ADMINISTRATIVE APPROVAL (LS) ADD2010-00079

ADMINISTRATIVE APPROVAL  
LEE COUNTY, FLORIDA

WHEREAS, Florida SE, Inc. filed an application for administrative approval to a Mixed Use Planned Development (MPD) on a project known as Coconut Point MPD to:

MASTER DEVELOPMENT PLAN  
PBA #2 - ADMIN LOT SPLIT (LOT #8)

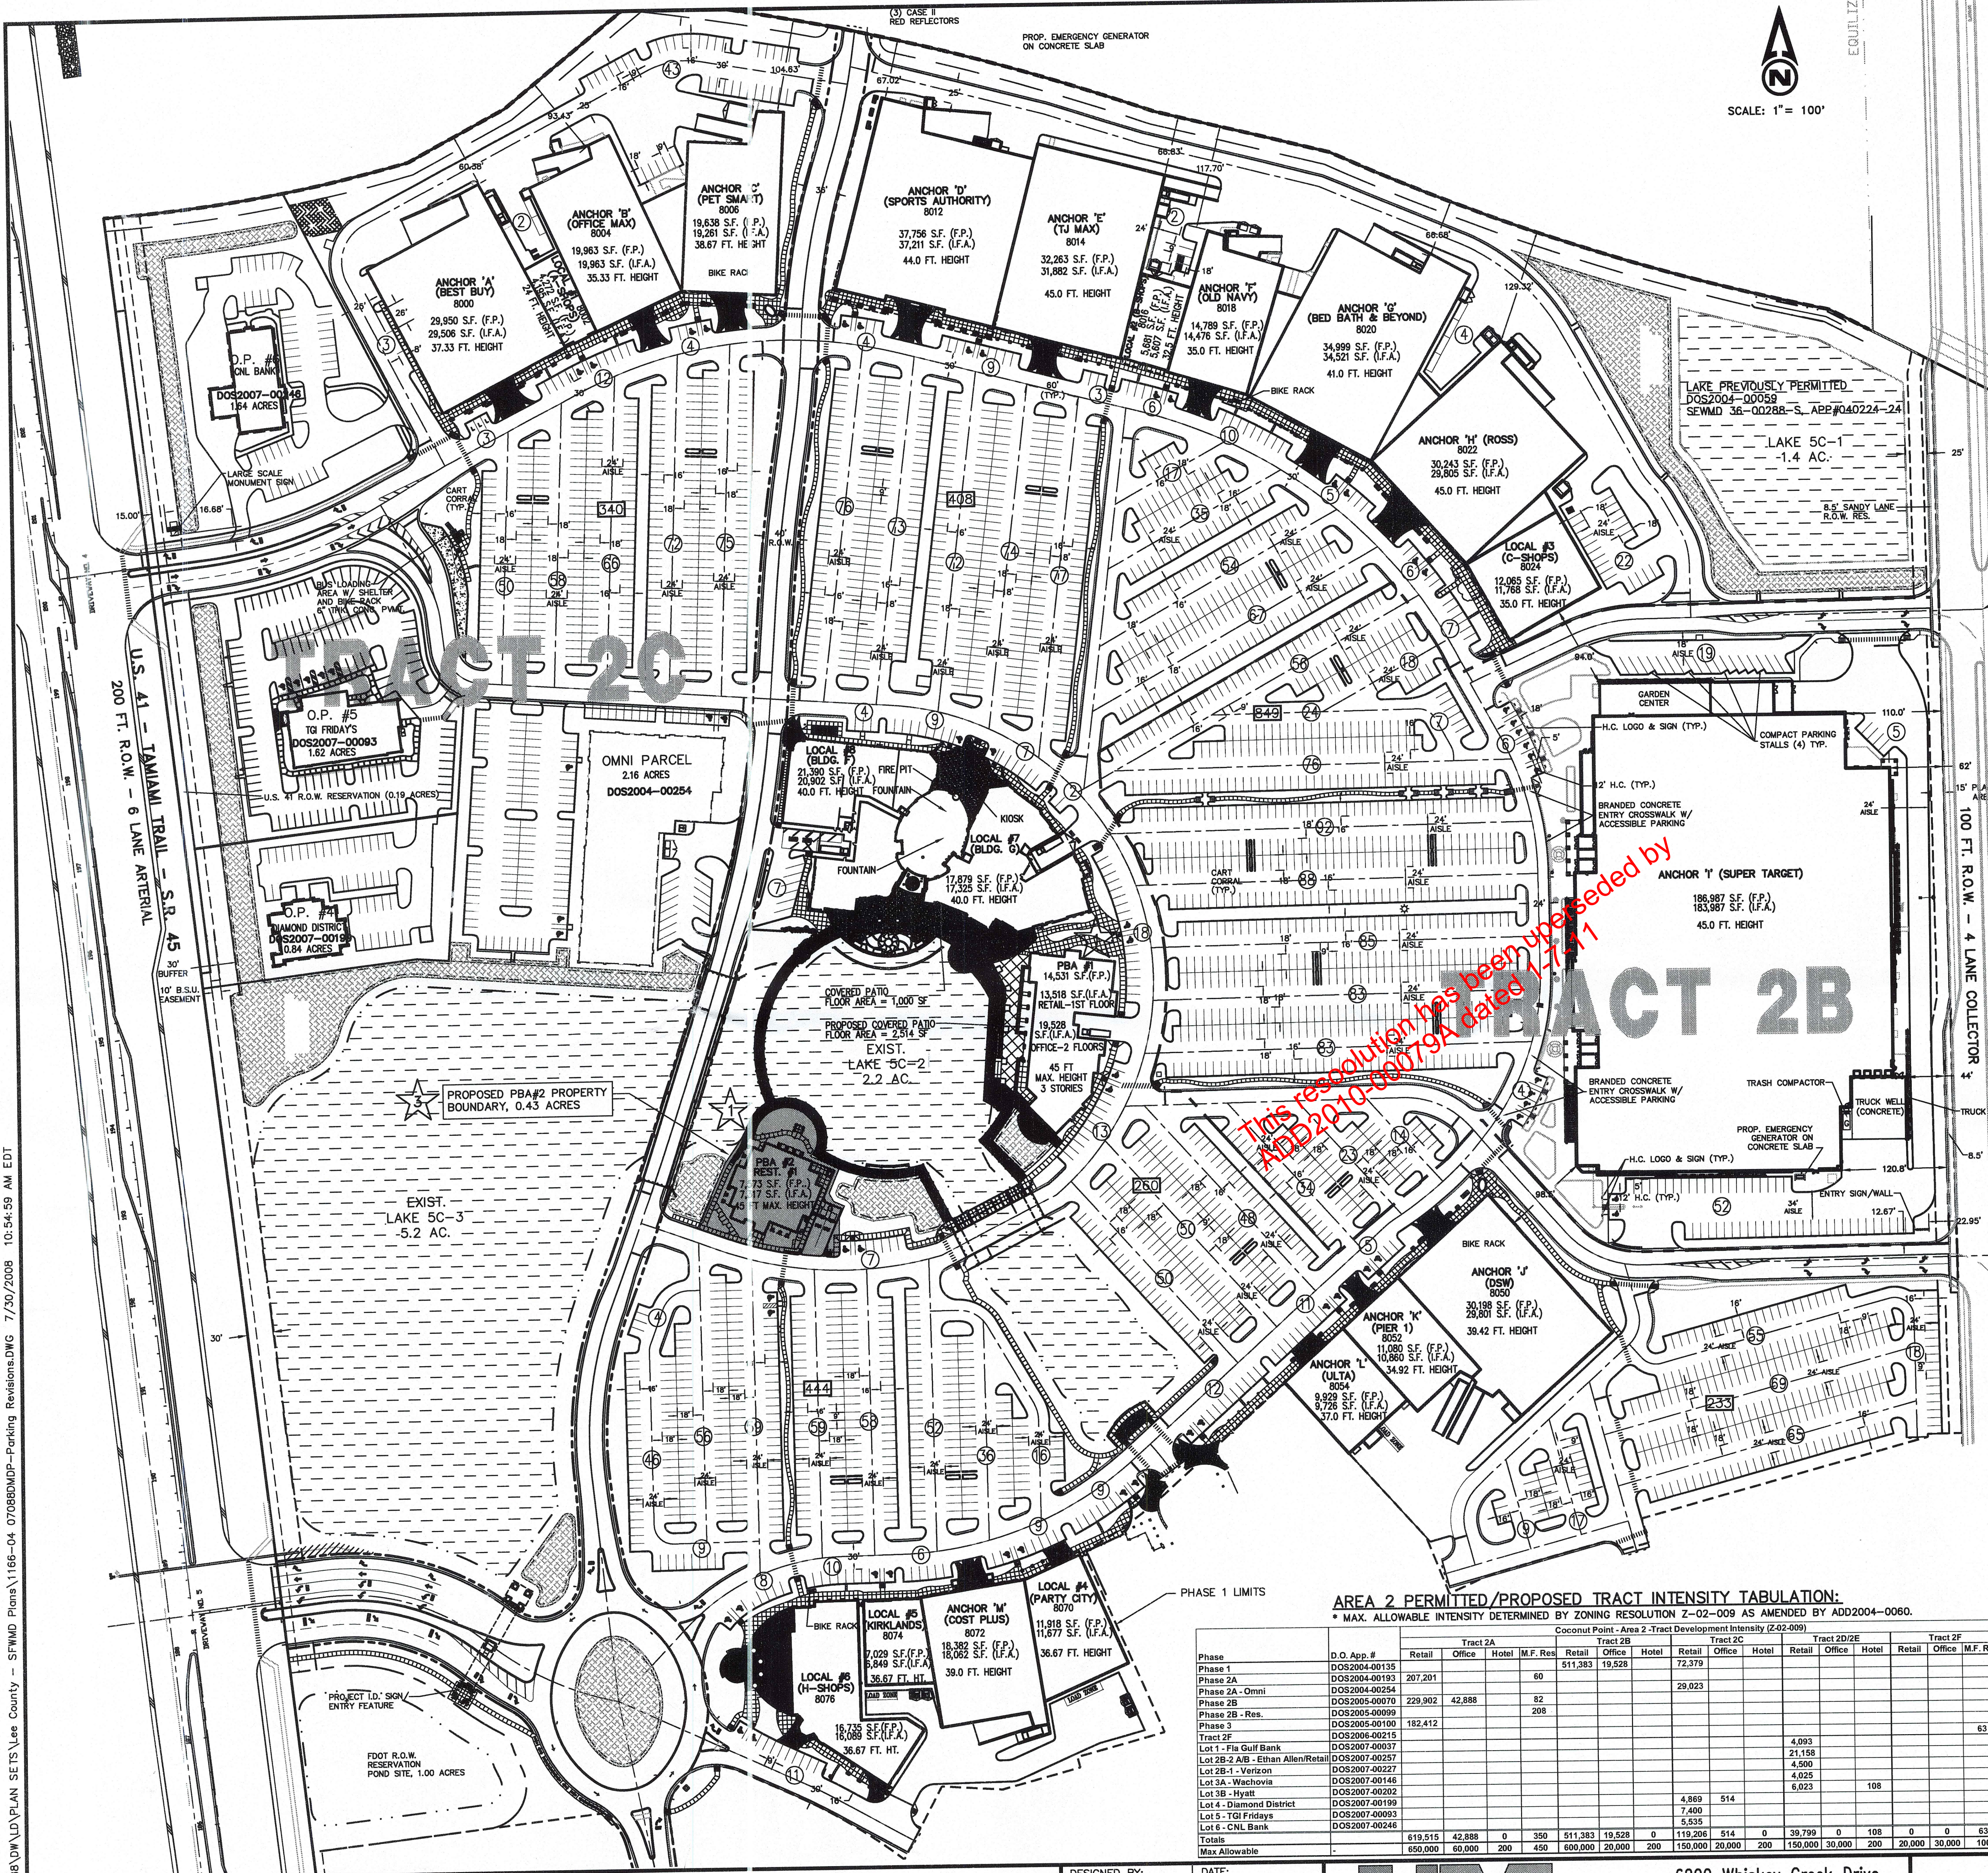
- ★ REVISE SITE PLAN: PBA #2 TO 7,317 SF (I.F.A.)
- ★ REVISE PARKING CALCS TO INCORPORATE INSIDE FLOOR AREA
- ★ ADMINISTRATIVE LOT SPLIT FOR PBA#2
